Dartmouth Park Options for potential future scheme

23 July 2018

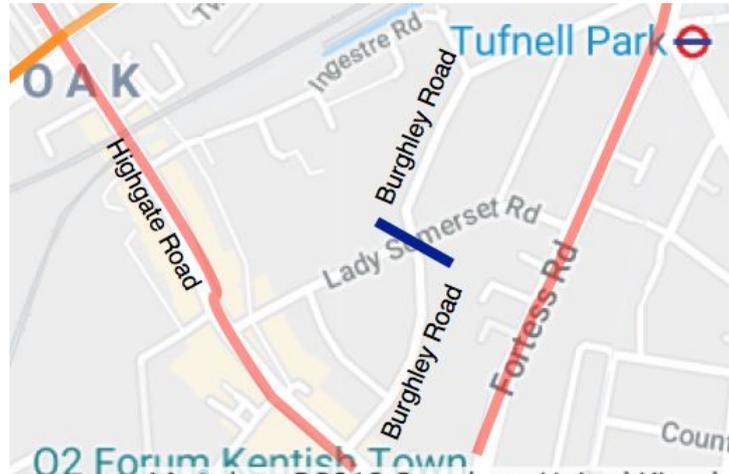
Chester Road and Swain's Lane require filtering by a Bus Gate

You provided traffic counts for Chester Road and as noted above, these are >400 mv/h at the PM peak. With the above proposed measures, most of the motor vehicles still wanting to make a journey in either direction between Dartmouth Park Hill and Highgate Road will use Swain's Lane and Chester Road, potentially bringing their motor-traffic levels higher than the current levels on Chetwynd Road.

The C11 bus route follows Swain's Lane and Chester Road eastbound (using St Alban's Road and Raydon Street westbound).

We therefore propose that a Bus Gate (which also allows cycles and emergency vehicles to pass) be placed on Chester Road to the west of the junction with Raydon Street.
